RENESAS TECHNICAL UPDATE

Product Category	MPU & MCU	Document No.	TN-16C-A194A/E	Rev.	1.00
Title	Errata to R32C/152 Group Hardware Manual	Information Category	Technical Notification		
Applicable Product	R32C/152 Group	Lot No.	Reference Document	R32C/152 Group Hardware Manual Rev. 1.03 (REJ09B0504-0103)

This document describes corrections to the R32C/152 Group Hardware Manual, Rev. 1.03.
The corrections are indicated in red in the list below.

Figure 7.1 Clock Generation Circuitry

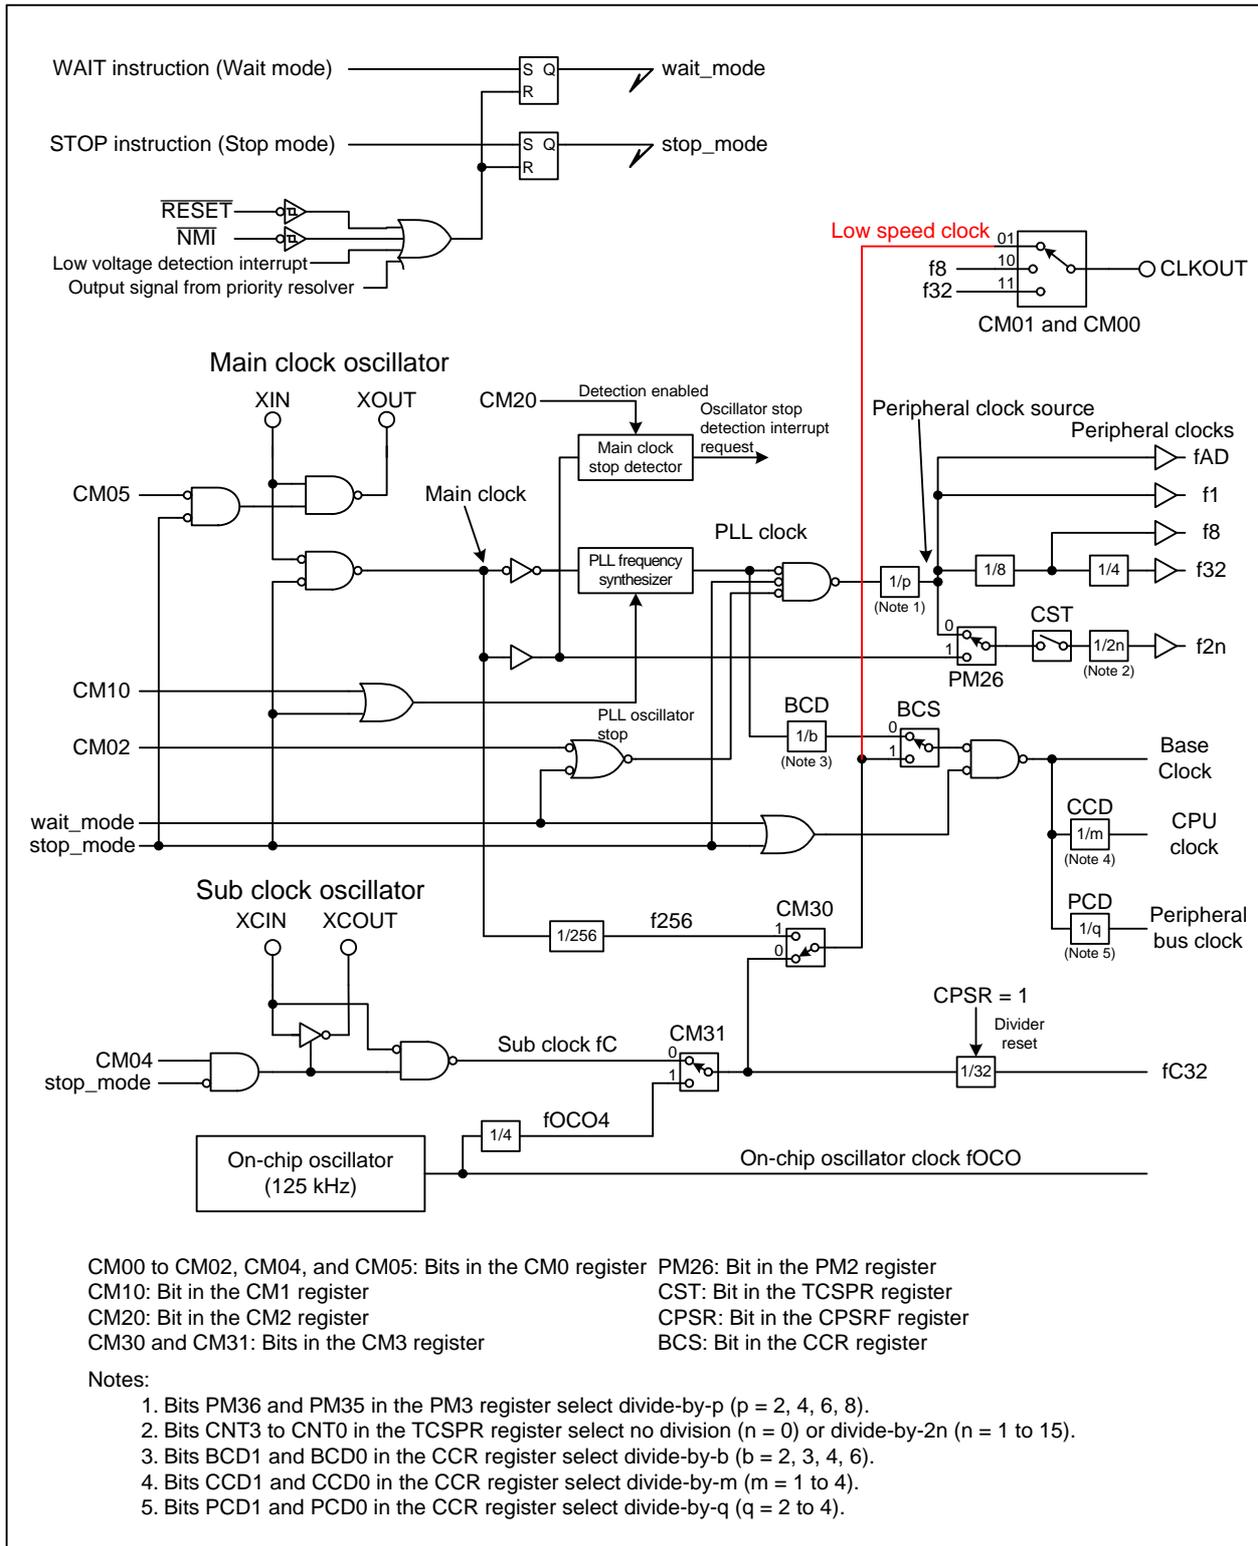
•Page 105 of 639, Figure 7.1 is corrected as follows:

Figure 7.20 State Transition (when the on-chip oscillator clock is used)

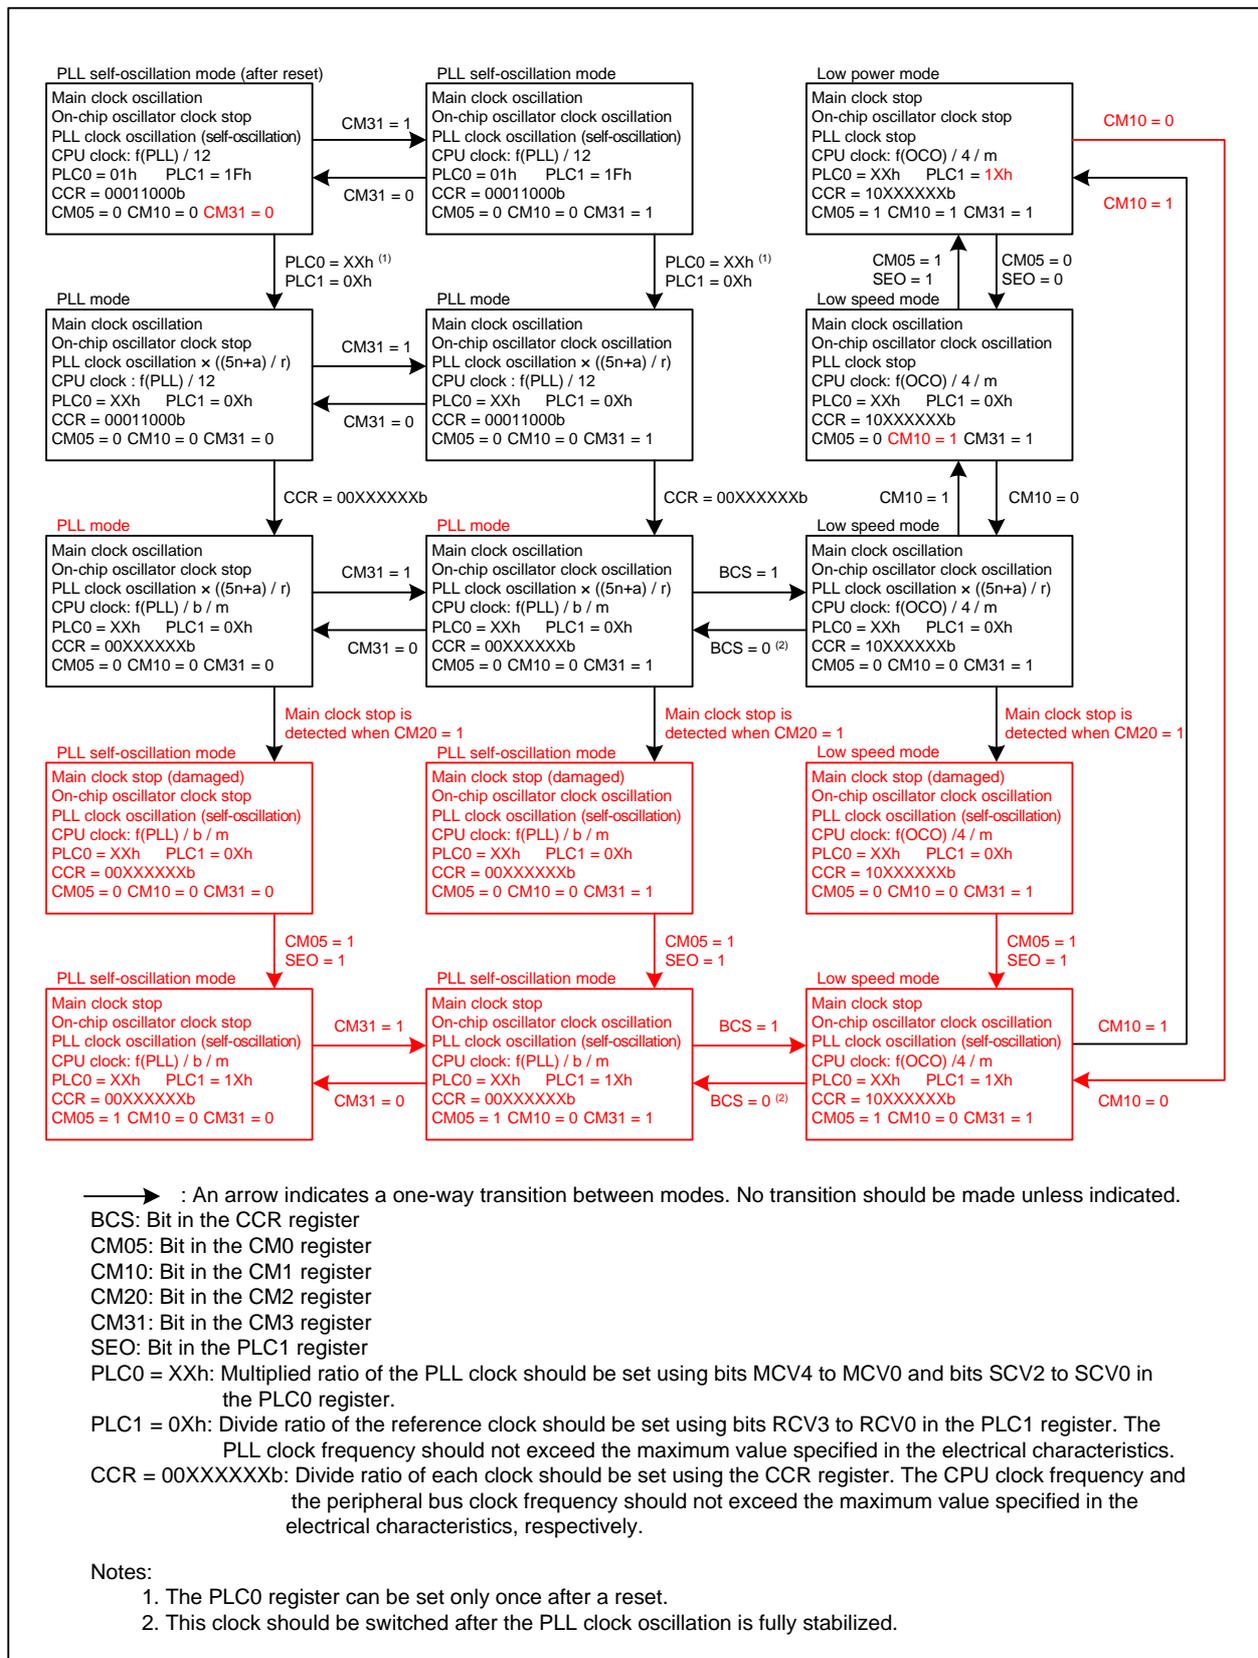
•Page 125 of 639, descriptions of “CM31 = 1” in the first row and “CM10 = 0” in the second row in Figure 7.20 are corrected, and the flowchart is clarified as follows:

(Note 3 “The CM05 bit is not set to 1 when an oscillator stop is detected through the oscillation stop detector.” is deleted from Figure 7.20)

Figure 10.8 Priority Resolver

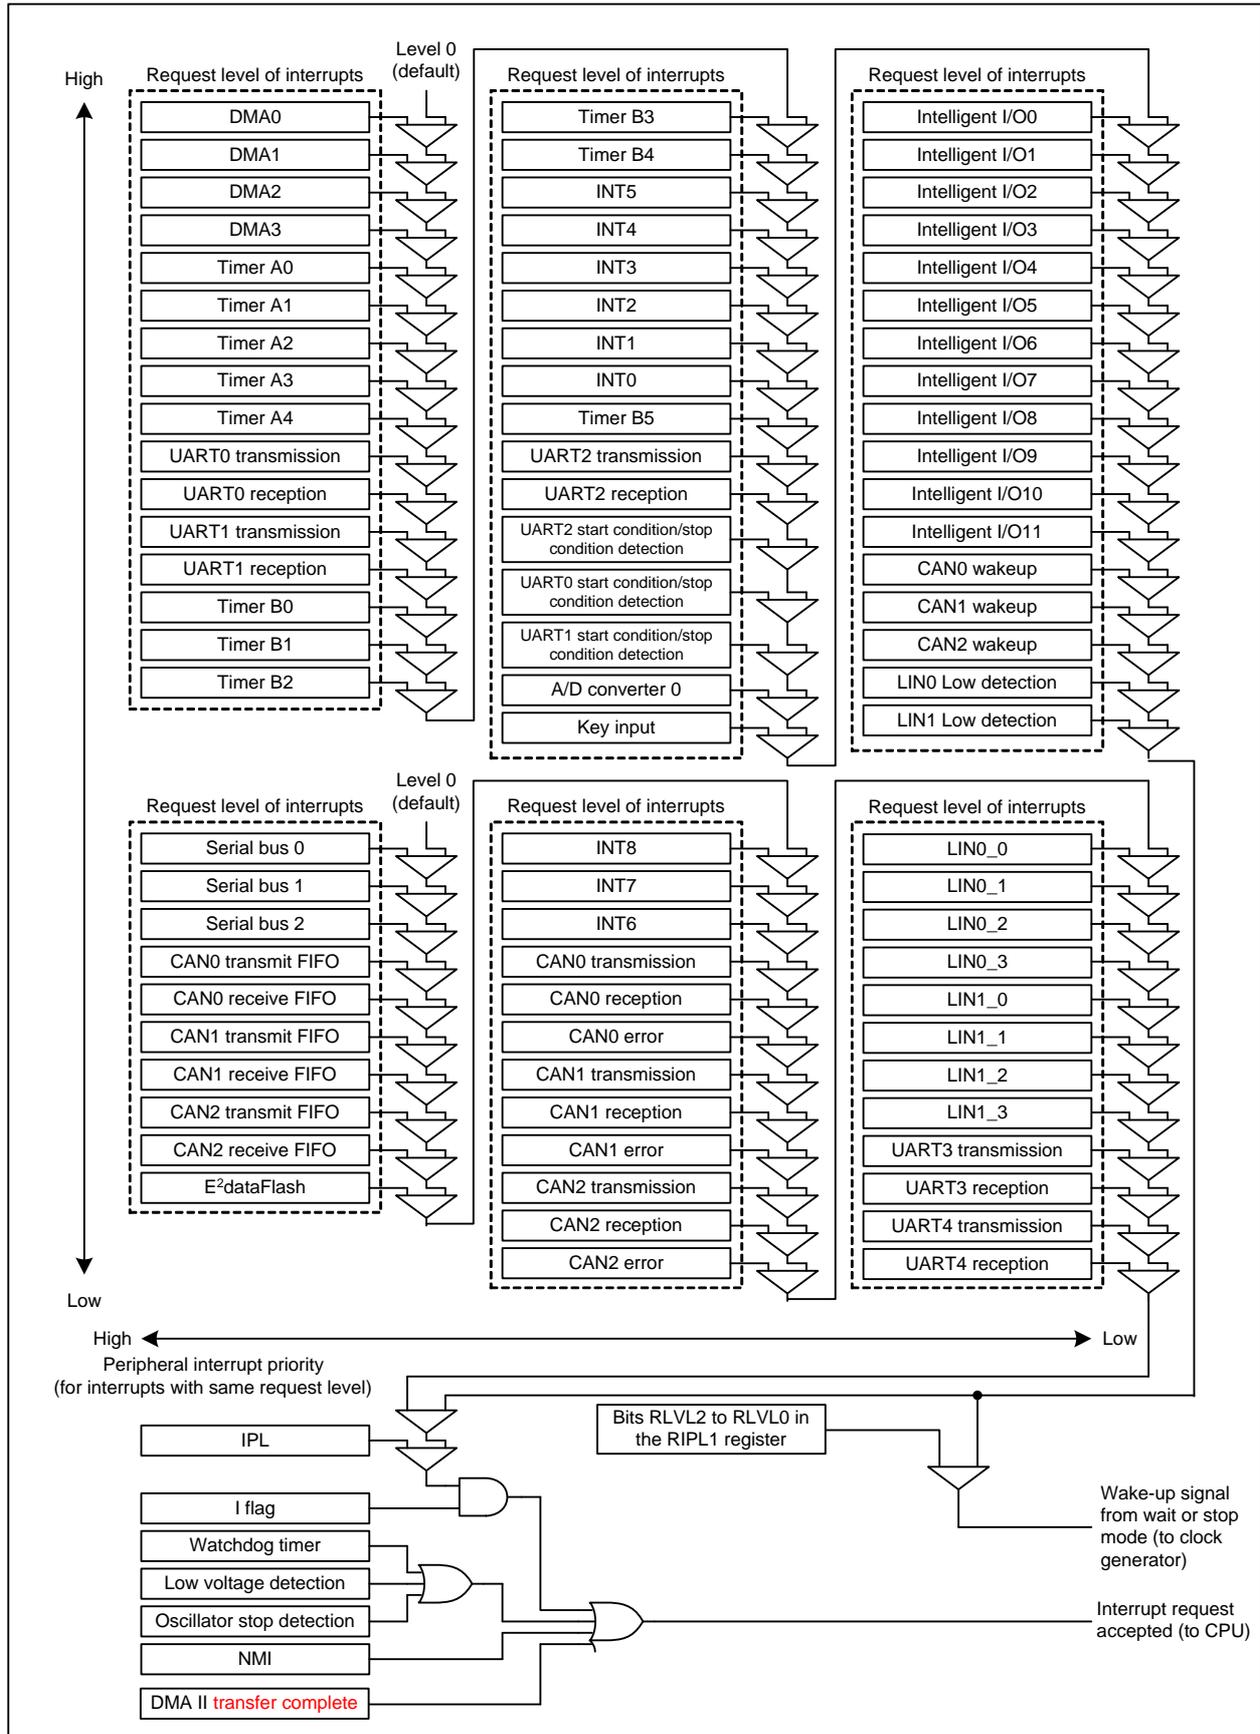
•Page 157 of 639, Figure 10.8 is corrected as follows:

(Description "Bits RLVL2 to RLVL0 in the RIPL2 register" and associated signal lines are deleted from Figure 10.8)

Figure 15.2 Timer B Configuration

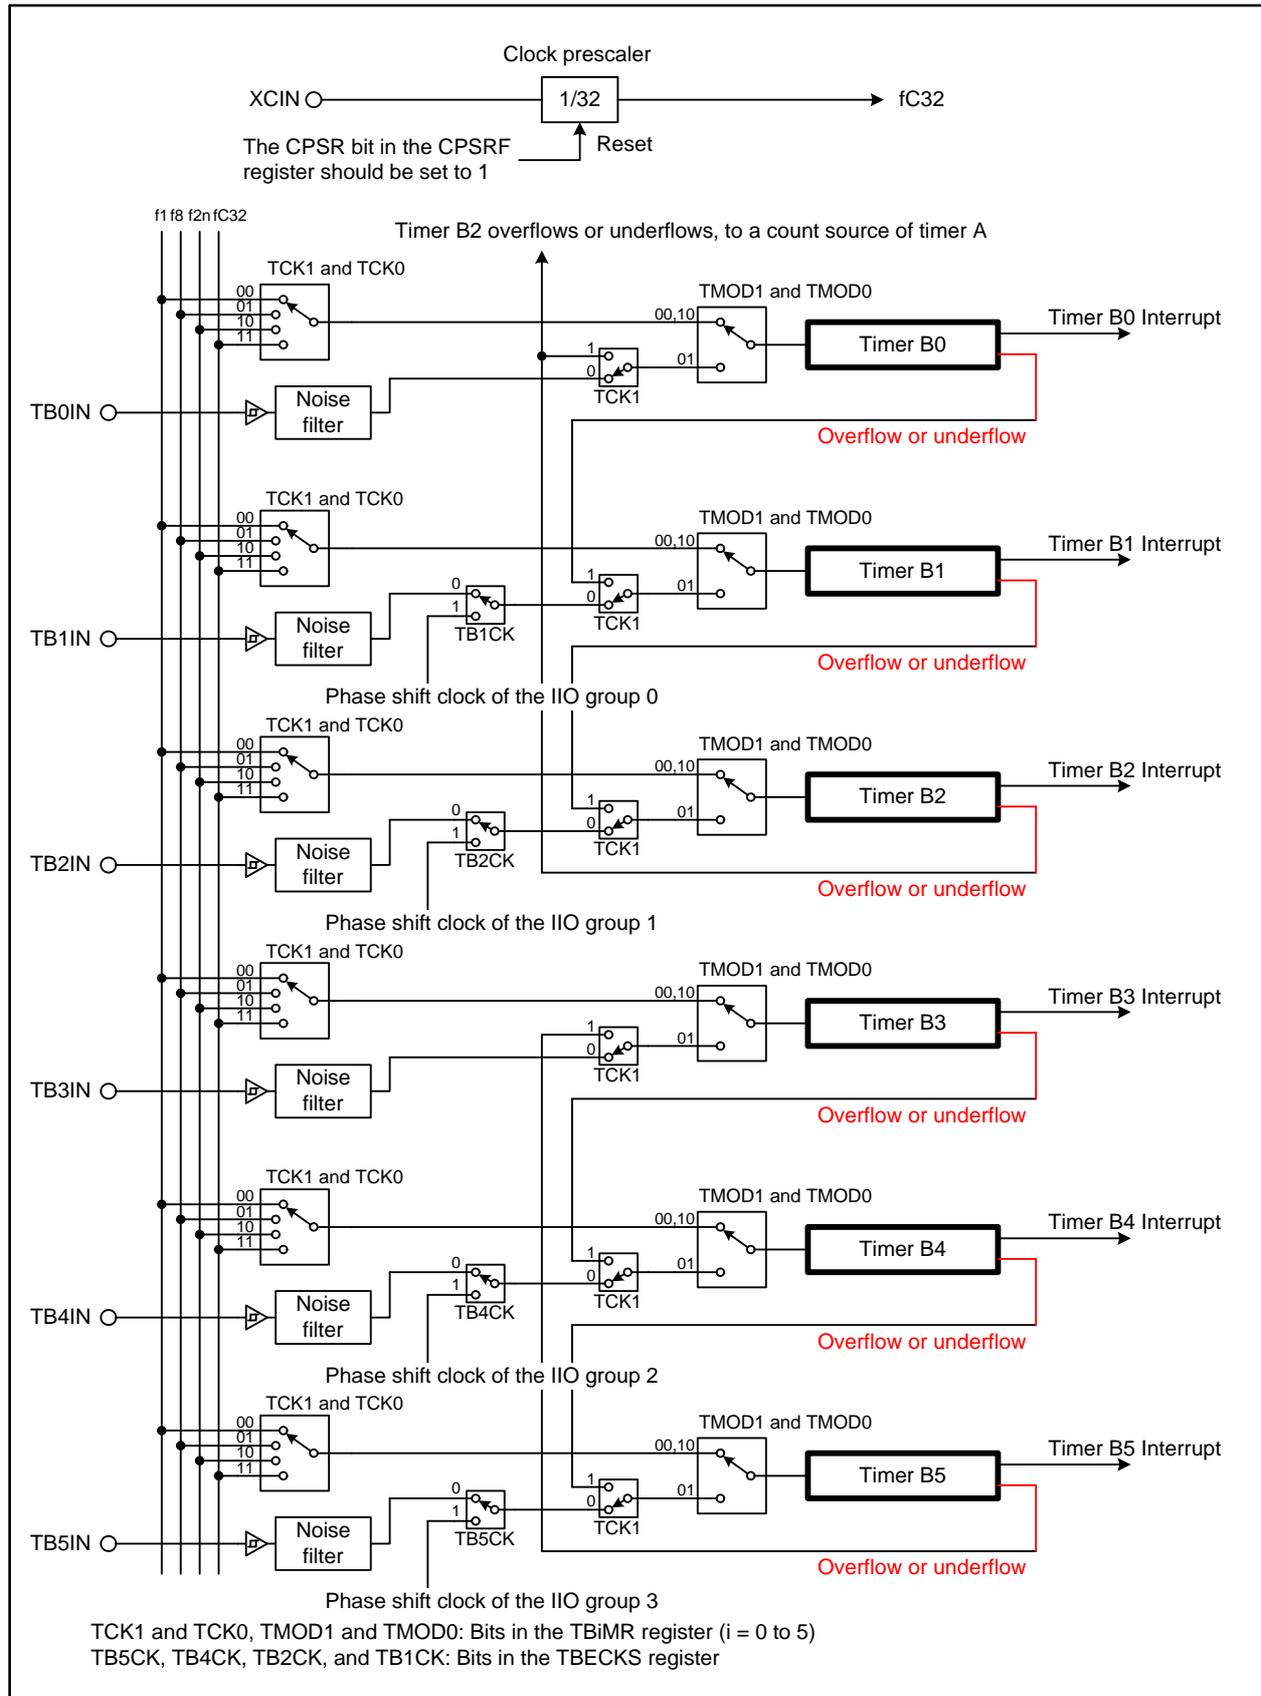
•Page 199 of 639, Figure 15.2 is corrected as follows:

Figure 24.30 Example of Setting Before Transmission to Wait Mode (i = 0, 1)

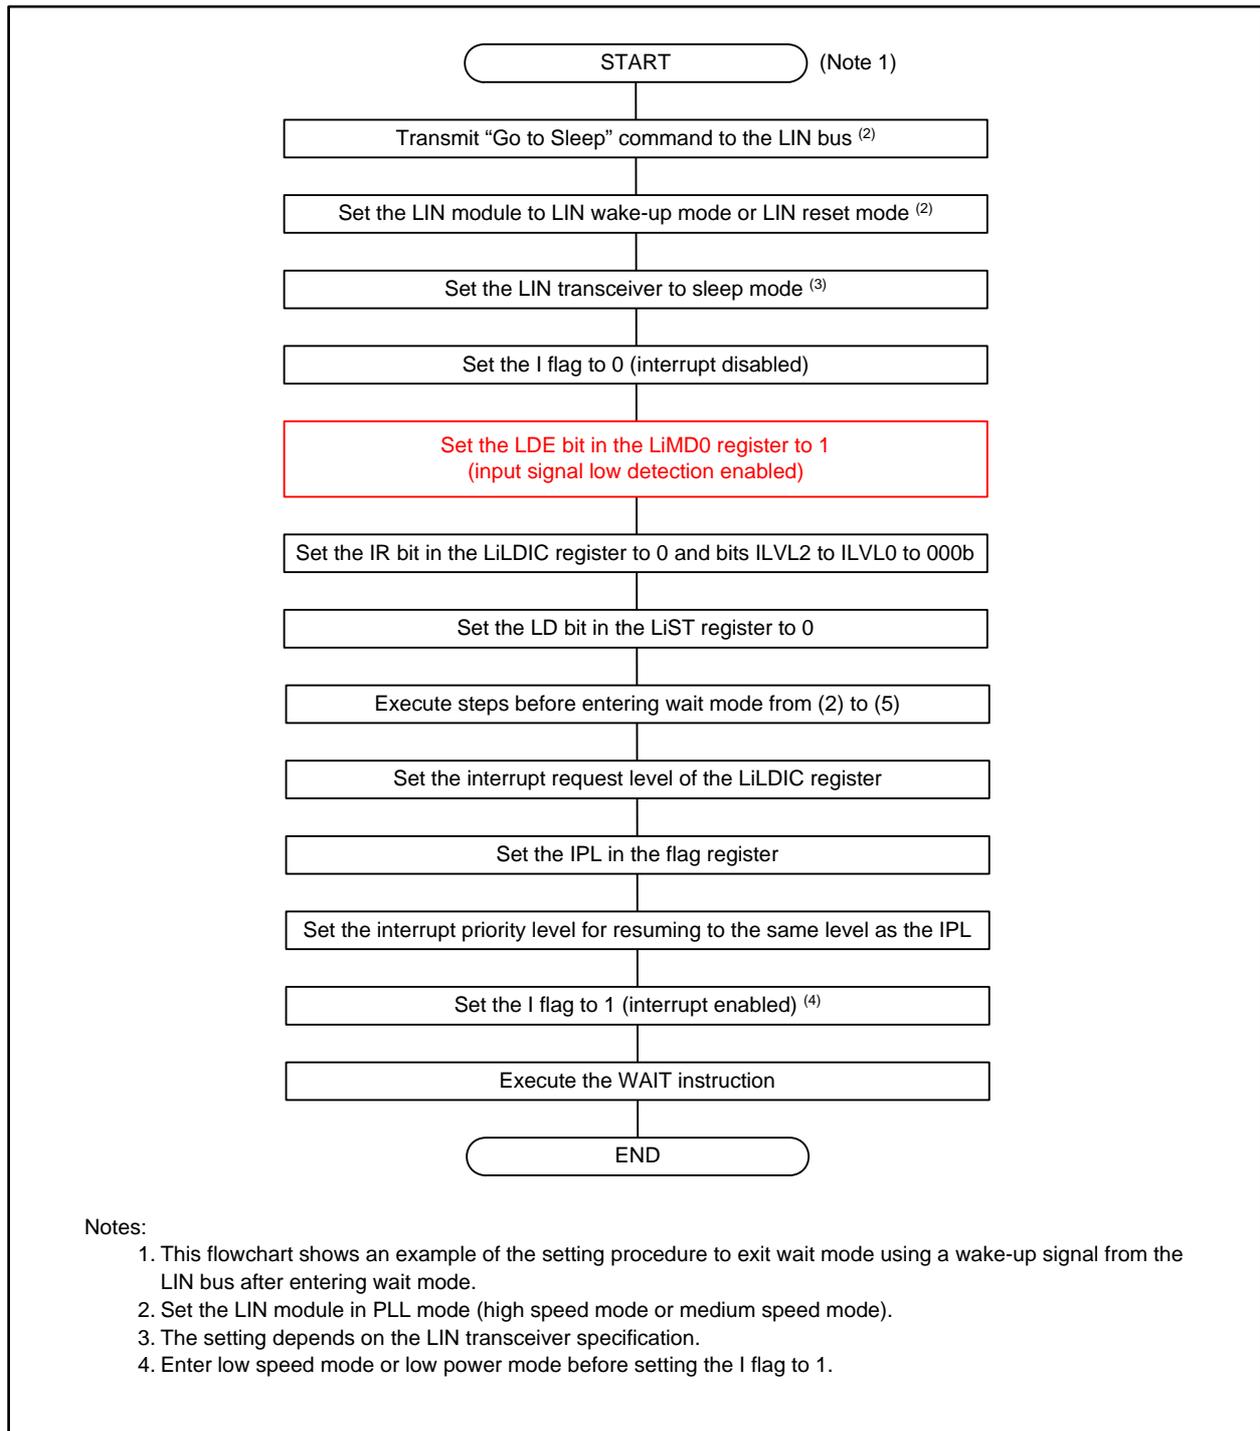
- Page 423 of 639, descriptions for (4) for “LIN Module Processing” in Table 24.5 are changed as follows:
 “Receive Data 2 due to start bit detection
 Receive Data 3 due to start bit detection
 (Repeat this process for the data length specified in bits RFDL3 to RFDL0 in the LiRFC register. Abort the reception and go to (5) if an error occurs. Checksum judgement is not performed in this case.)”
- Page 426 of 639, description “BPR0” in Note 1 of Table 24.6 is corrected as follows:
 “BRP0”
- Page 433 of 639, Figure 24.30 is corrected as follows:
